Product Change Notification: E-19-014772

PCN Date: 16-OCT-19

TERMINAL BLOCK MULTIPLE HEADER, 90 AND 180 DEGREE CLOSED ENDS

Polarized, Right angle version

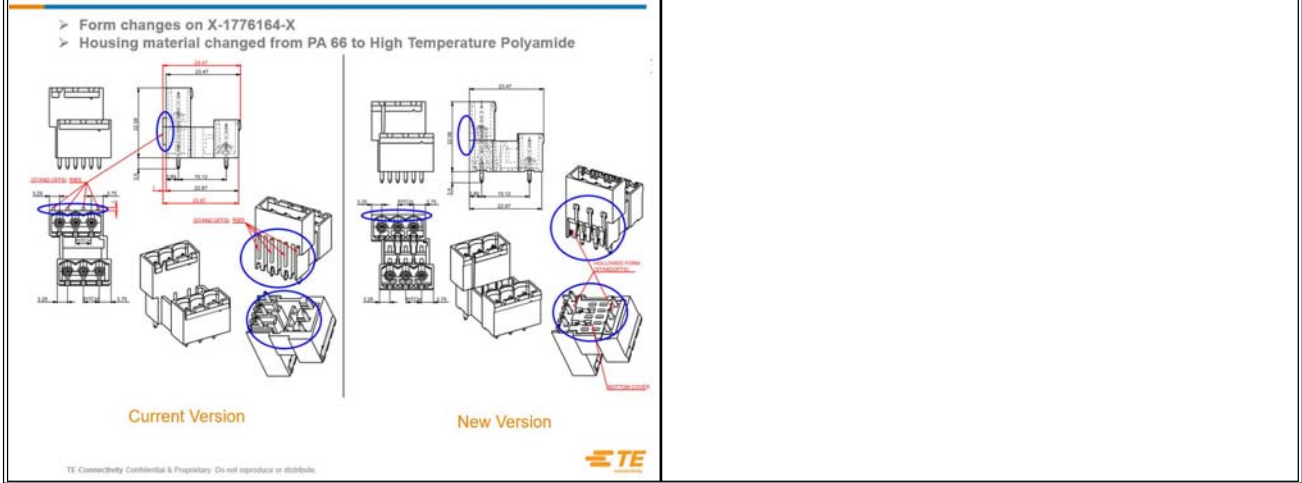
- Stand off is modified in housing (hollowed form shape). - Plastic material of the housing which are currently made of PA 66 changed to HIGH TEMPERATURE POLYAMIDE. - Minor appearance difference in housing color tone from the current version due to change in plastic material to High temp PA. - No changes in mat-ability, new version can be connected to the same types of female connectors. - Refer to attachment for detailed changes on the form of the housing. - The new version product can be easily distinguished from the current version through the deeper standoffs.

> Form changes on X-284061-X
> Housing material changed from PA 66 to High Temperature Polyamide
